# MAX9295D DEV\_REV=8 (D-0C) ERRATA SHEET

Corresponds to data sheet 19-100518; Rev6; 11/23

## DEV\_REV=8 (per reading register 0xE)

### 16) ADC input Multiplexer is incorrectly documented in data sheet

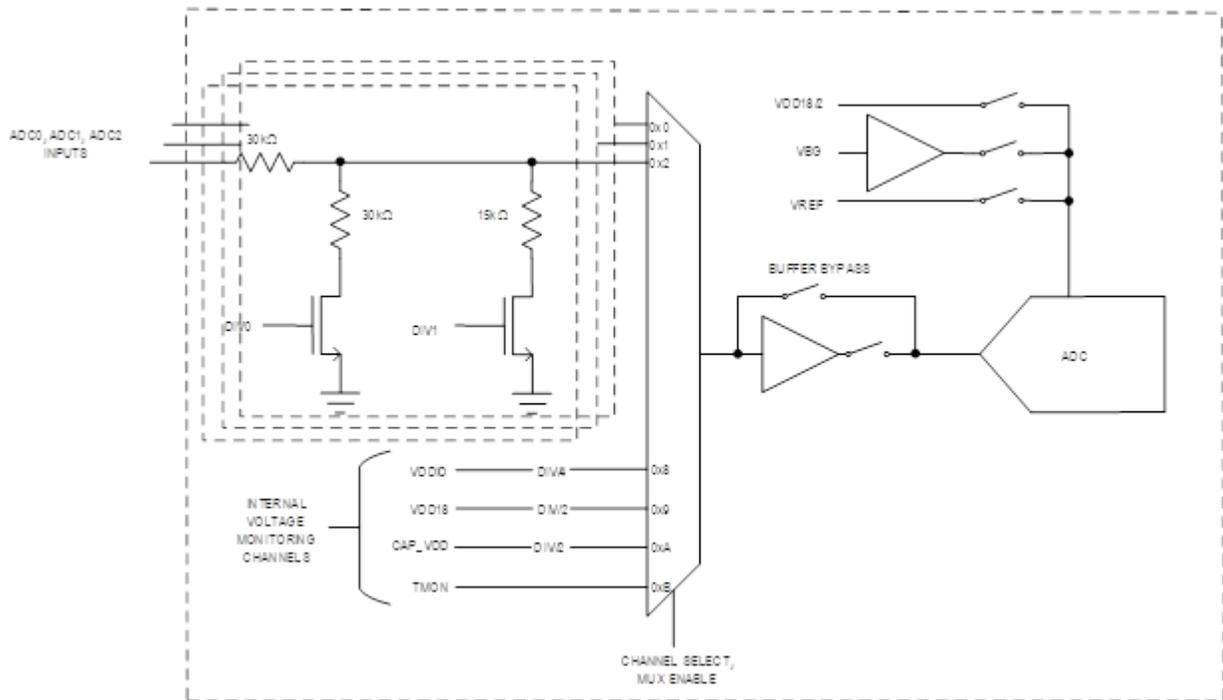
Input 0xA of the ADC input multiplexer (register 0x501, bits [7..4]) should be described as CAP\_VDD, not VDD in data sheet figure 32. The ADC input multiplexer is incorrectly documented in data sheet

Use register definition is update in table below.

**17) ADC registers incorrectly documented in data sheet**

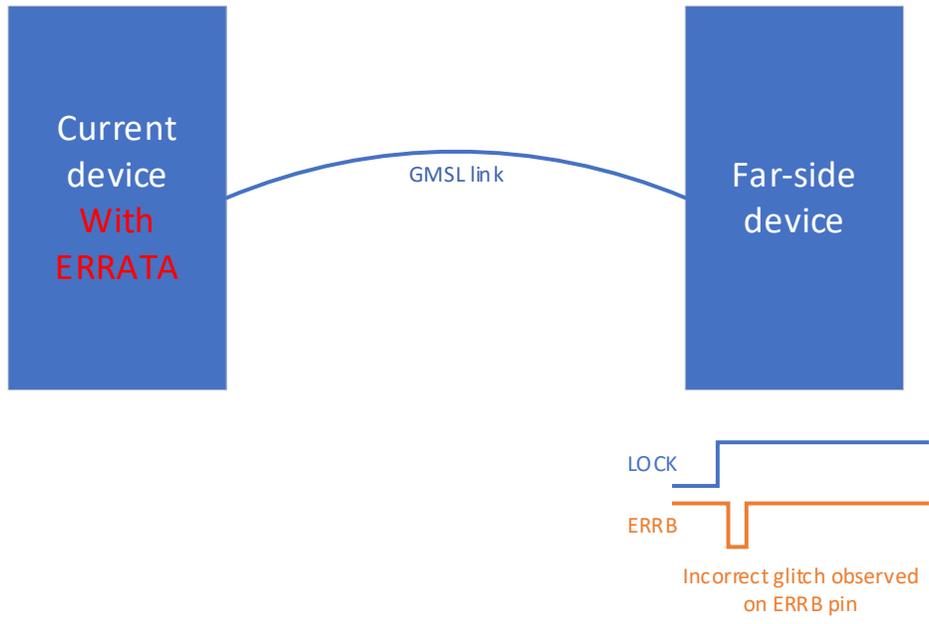
If REM\_ERR\_OEN is enabled on far-side device before link lock, there will be a ~1us glitch on far-side ERRB upon link lock if there are no errors on both sides of the link.

Enable REM\_ERR\_OEN on far-side device only after link lock. If REM\_ERR\_OEN on far-side device is 1 before link lock:

If SOC is on far-side device:

1. Disable ERR\_RX\_EN local before link lock
2. Wait for link lock
3. Disable ERR\_TX\_EN remote
4. Enable ERR\_RX\_EN local
5. Enable ERR\_TX\_EN remote
